S96-2 SCOPE

MOD2019/0312

CLONNY'S AT CLONTARF CLONTARF RESERVE

ELEVATIONS

SOUTH SIDE ELEVATION

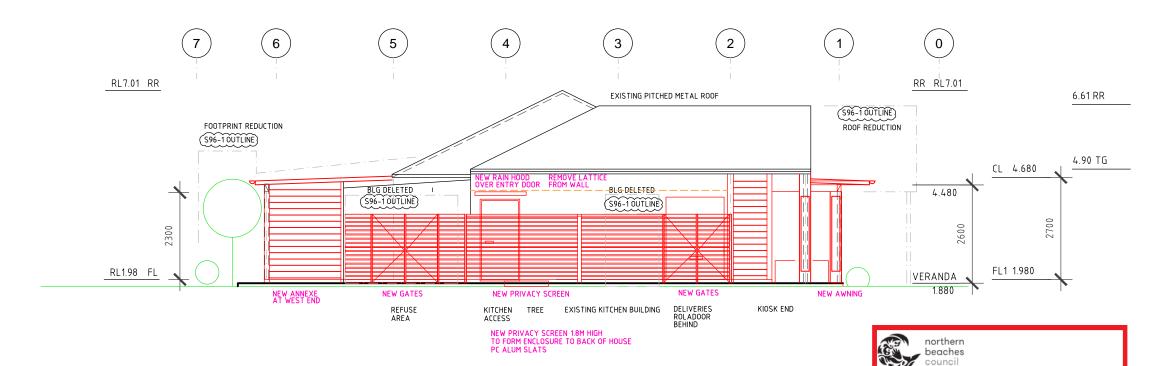
RETAIN EXISTING ROOF - 26 DEGREE PITCHED CUSTOM ORB PROFILE PAINT OR REPLACE AS REQUIRED REMOVE SKILLION ROOF & GUTTERS

NEW WIDER VERANDA EXISTING SKILLION 67sm PROPOSED SKILLION ROOF 82sm INC. AREA ACROSS KIOSK FORECOURT BONDOR SOLAR PANEL SPANDECK PROFILE 2 DEGREE PITCH NEW 150 CB HALF ROUND GUTTERS NEW 150 CB DOWNPIPES

NEW PC ALUM WINDOWS & DOORS TIMBER FRAME WALLS CLADDING - HARDIE LINEA BOARDS

FLOORS - CONCRETE POLISHED EXTERNAL CONCRETE SLABS CEILINGS - VEE JOINT BOARDS

PRIVACY SCREEN & GATES PC ALUM HORIZONTAL SLATS

DELETION / REDUCTION OF WORKS VERANDA WIDTH REDUCED & LOWERED KIOSK GABLE EXTENSION DELETED FURNITURE STORE DELETED REFUSE STORE DELETED SOUTH END BATHROOM DELETED REDUCTION IN FLOOR SPACE FOOTPRINT REDUCTION IN PAVING AREA

REPLACE VERANDA, WIDEN BY 800 VERANDA TO HOUSE CHILDREN'S PLAY ZONE & STOREROOM – SOUTH END VERANDA FORMS NEW AWNING TO KIOSK NEW EAST END SCREENING FENCE
